Final Product/Process Change Notification

Document #:FPCN22766XA1

Title of Change:	Split of FPCN22766X - Qualify ASE Kunshan as alternative assembly site for SOIC7.													
Proposed First Ship date:	01 Aug 2020 or earlier if approved by customer													
Contact Information:	Contact your local ON Semiconductor Sales Office or Marty.Paul@onsemi.com													
PCN Samples Contact:	Contact your local ON Semiconductor Sales Office or <PCN.samples@onsemi.com>. Sample requests are to be submitted no later than 30 days from the date of first notification, Initial PCN or Final PCN, for this change. Samples delivery timing will be subject to request date, sample quantity and special customer packing/label requirements.													
Additional Reliability Data:	Contact your local ON Semiconductor Sales Office or Shiela.Crosby@onsemi.com													
Type of Notification:	This is a Final Product/Process Change Notification (FPCN) sent to customers. FPCNs are issued 90 days prior to implementation of the change. ON Semiconductor will consider this change accepted, unless an inquiry is made in writing within 30 days of delivery of this notice. To do so, contact PCN.Support@onsemi.c

OSPI: 3 Flag sizes

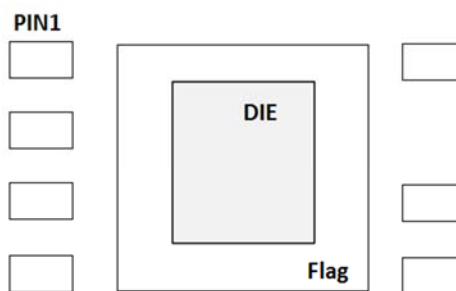
OSPI	ASEKS
Product marking change	Assembly Location: P	Assembly Location: AK

ASEKS: 1 Flag size

OSPI: 3 Flag sizes

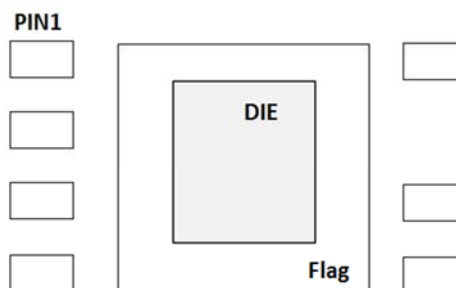
OSPI	ASEKS
製品マーキング変更	組立場所: P	組立場所: AK

ASEKS: 1 Flag size
